**Public Review Draft GSP—  
Public Comment Letters**

## Re: Public Comment Letter for the San Pasqual Valley Groundwater Basin Draft GSP

# San Pasqual Valley Groundwater Basin Jurisdictional Boundaries

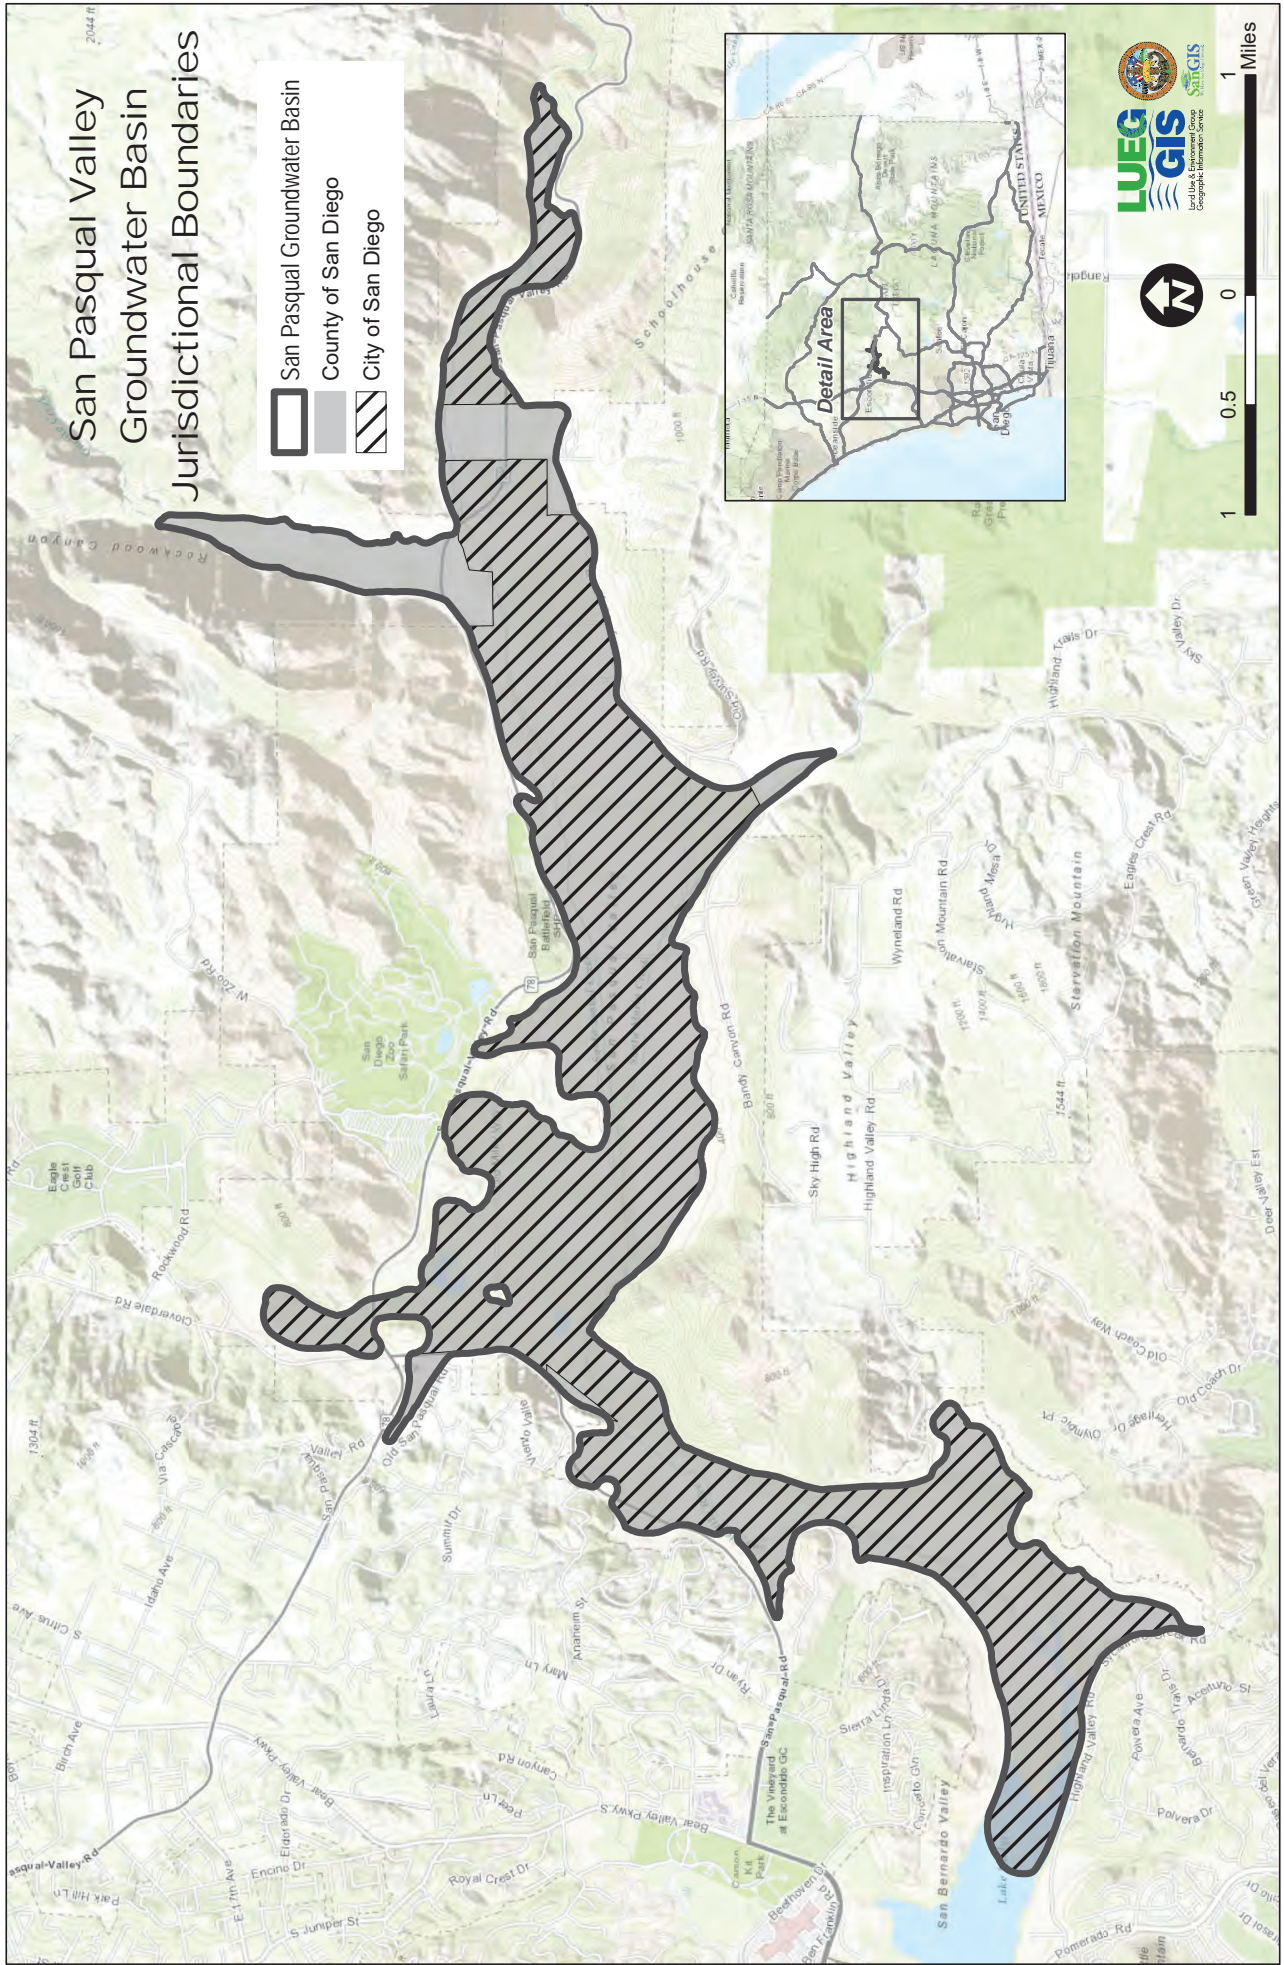
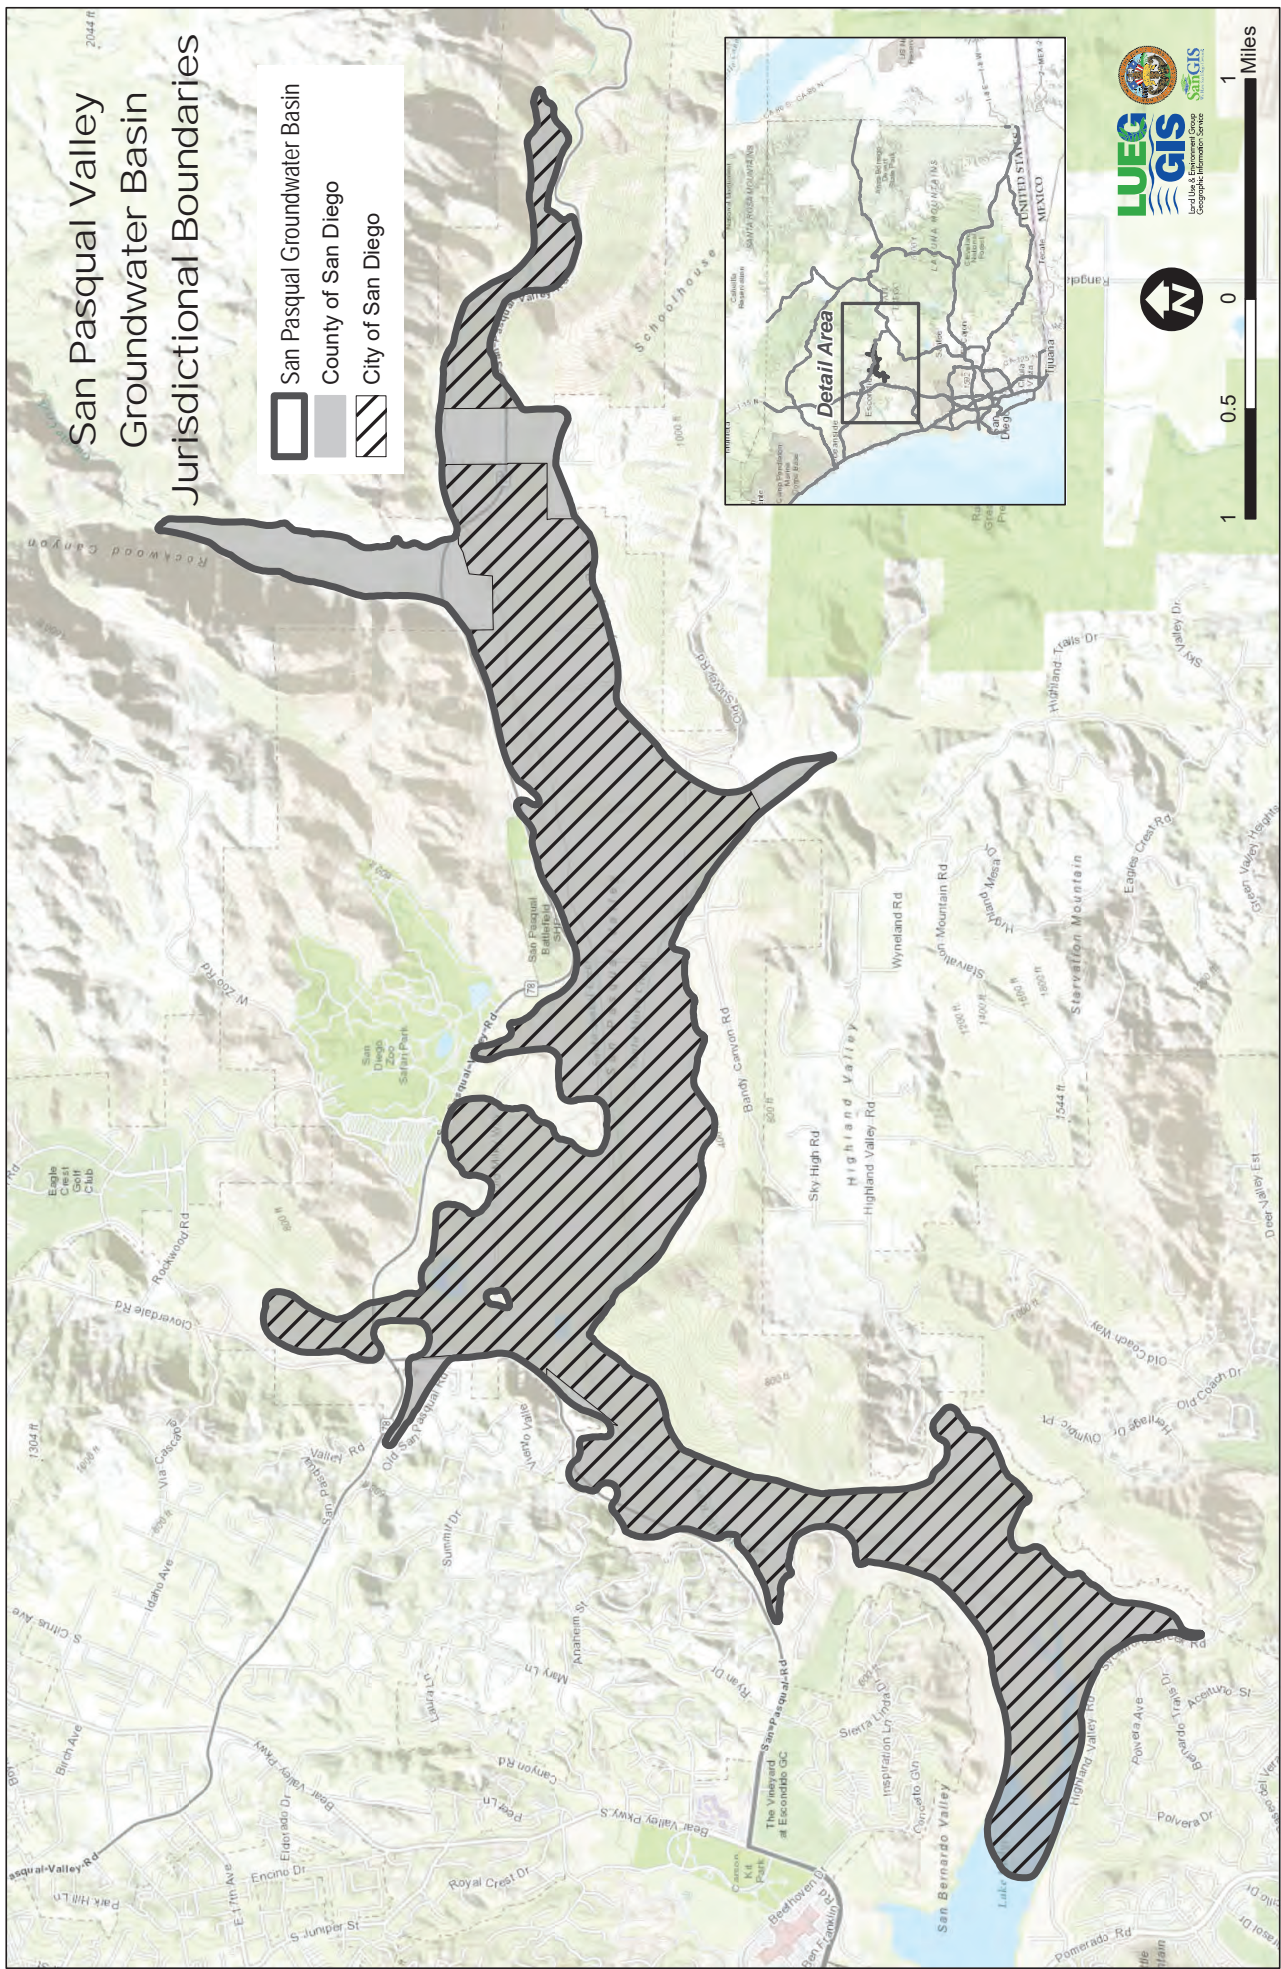
Frank Konyon	Konyon Dairy	7/8/2021	Jurisdictional Boundary	Fig. 2-5	All County land needs to be shown in the figure. It appears that not all County land is shown in the figure, mainly near Santa
